Service Bulletin: TSB-012

System: Chassis/Suspension

The intent of this bulletin is to request an additional inspection during Pre-Delivery Inspection (PDI) or at the 2500-mile interval to ensure durability and performance. Please inspect the installation of the steering gear outer tie rod on the Mullen THREE.

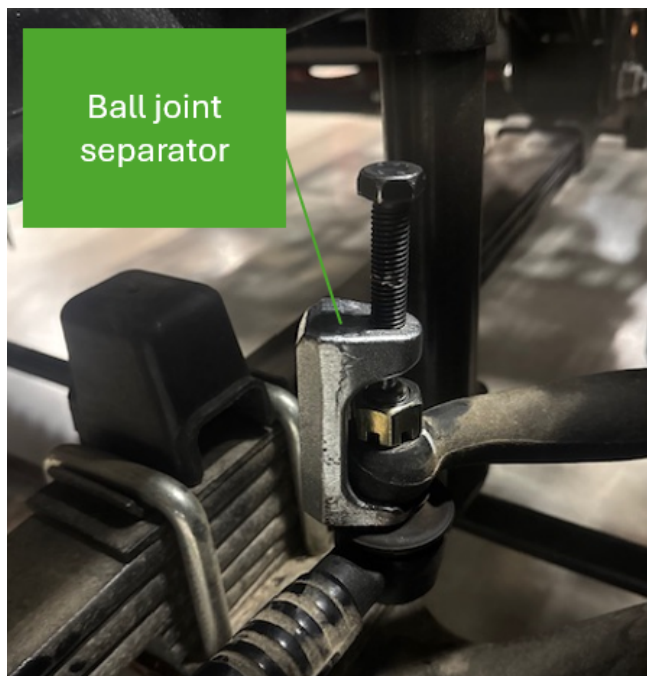
1. Tilt the cab. See the owner's manual for instructions.
2. Visual inspection of the steering gear outer tie rod orientation, located on the driver's side of vehicle.
 - The arrow inscribed on the tie rod is to be pointing towards the front of the vehicle.

Outer Tie Rod installed with orientation arrow to front of vehicle

Outer Tie Rod installed with orientation arrow installed to rear of vehicle

3. If tie rod orientation is rearward, proceed with the reinstallation procedure.

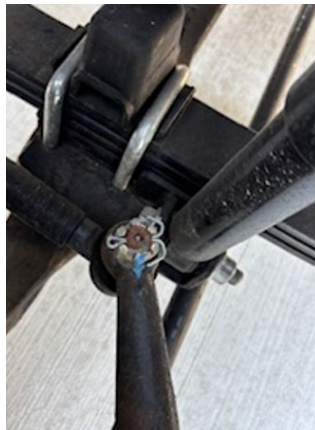
5. Remove the castle nuts and the ball joint separator.
6. Inspect the tie rod and tire for wear.
7. Reinstall the tie rod with a forward orientation.

8. Torque the castle nuts to 130 - 180 Nm, mark the castle nut with a torque witness mark using a china marker.
9. Install the cotter pins and bend the fingers past 90 degrees
